**Wellcome Genome Campus, Hinxton**  
**Condition 24 (Lighting) – Site Wide Lighting Strategy**  
**Response to Hinxton Parish Council Comments**

The table below reproduces the comments provided by Hinxton Parish Council and provides a response indicating where amendments have been made to the Site Wide Lighting Strategy.

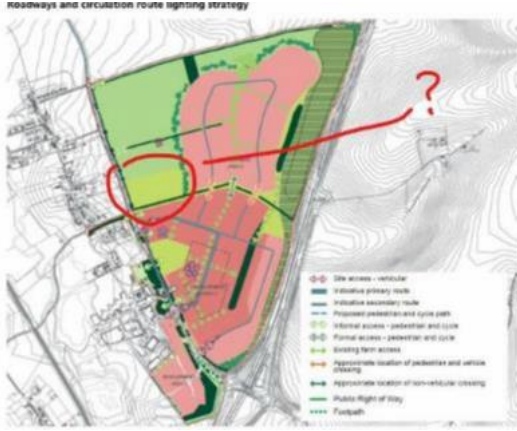
4.	Site Location	<p>Site geography: development areas DA3 and DA1 are on much higher ground than DA2. They are rural agricultural fields with no lighting at all within their boundaries at present.</p>	<p>Response</p> <p>Whilst the existing area of proposed development and the proposed buffer zone are currently unilluminated, the level</p>	<p>Reply</p> <p>We don't agree that the site be classified as Zone E2. Indeed the strategy acknowledges that the Baseline conditions</p>

No.	Item	HPC Comment	Response on behalf of U&C - Comment or amendment to site Wide Lighting Strategy	HPC Reply
		<p>The site location is assessed to be within "E2 Environmental Zone Lighting".</p> <p>E2 covers sparsely inhabited rural areas, village or relatively dark outer suburban locations.</p> <p>We would submit that a distinction needs to be made between DA3 and DA1 on the one hand (both of which at present are agricultural land with no lighting at all) and DA2, which sits to the southerly end of the existing campus. We submit that DA3 and DA1 should properly be classified as E1 Environmental Zone Lighting/relatively uninhabited rural areas and that the lighting principles for DA3 and DA1 should be appropriate for an E1 classification.</p>	<p>of sky glow present above the area is recorded as being of Bortle Scale Class 4, indicating an area of rural/suburban transition. It is envisaged that the area of development would upon completion would be classified as a Zone E2.</p> <p>The areas shown within the OPA to be 'dark zones' (for instance the buffer area between DA3 and the A1301), and areas with sensitive receptors are shown within the Lighting Strategy to be maintained as unilluminated or be subject to specific lighting conditions during night-time and as such in places should, adhere to a <i>similar</i> criterion to those applicable for a Zone E1.</p>	<p>have been updated under the revised strategy paper of 24 Feb 22.</p> <p>The strategy paper says:</p> <p>"Previously the Expansion Land was categorized as an E1 Environmental Lighting Zone condition (natural). Based on updated observations and data on existing conditions, with the prevalent levels of sky glow being a contributing factor. The magnitude of sky glow for the area of the development being with the region of 20.83, which falls within a Bortle Scale rating of class 4, equating to an area of rural/suburban transition as per an E2 zoning classification by the ILP".</p> <p>The Expansion land is rural agricultural fields. There is no "suburban transition" into the village of Hinxton.</p> <p>The applicant then says the "dark zones" will be unilluminated or subject to "specific lighting conditions during night time". We await clarification of any "specific lighting conditions" while noting they will be similar to those applicable for zone E1.</p> <p>(we also note from comments against Figure 4-6 below, that there will be "no lighting treatment" in the buffer zone area between DA3 and the 1301).</p>
